Appendix G Lowering Speed Limits

RE: Speed Limit Reduction request for VT 22A in Orwell

**Road Safety Audit Review
VT 22 A @ VT 73
Orwell**

VT 22A @ VT 73, Orwell Road Safety Audit Review Review Report

VT 22A North @ VT 73 State Numbered Town highway

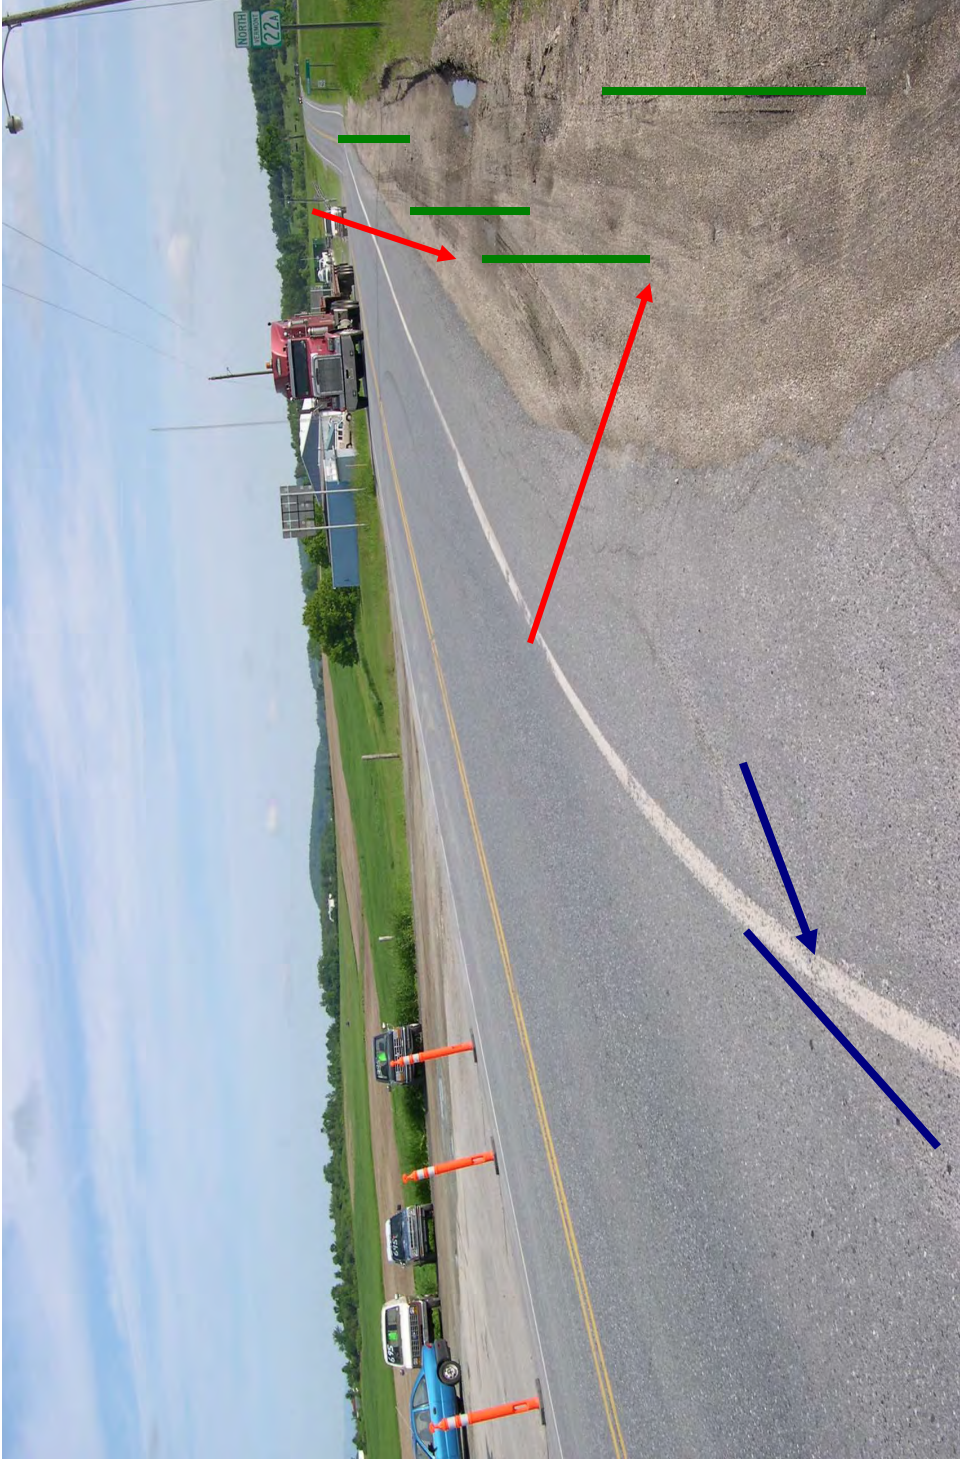
In the picture above

1. The red arrows show the parking problem at the Gulf Gas Station. Installation of a raised island can solve the problem.
2. The blue arrow shows the Stop Bar current condition and the green arrow shows where it should be moved to get better sight distance.

In the picture above

- 1. The red arrows shows the area where trucks park at the edge of pavement and the green lines show that the installation of delineators could stop trucks parking there.**
- 2. The blue arrow shows that the turning radius should be changed.**

1. Work order was prepared for **#3 above** replace all flashing beacon heads with LED's. (6/13/03)
2. Points **#1, # 2** and **# 4**, has been discussed with Marcos Miller and work orders would be completed with in two weeks or so. (6/12/03)
- 3 After discussing with Al Wright on 06/16/03, Don Gilman is going to look after the island issue.
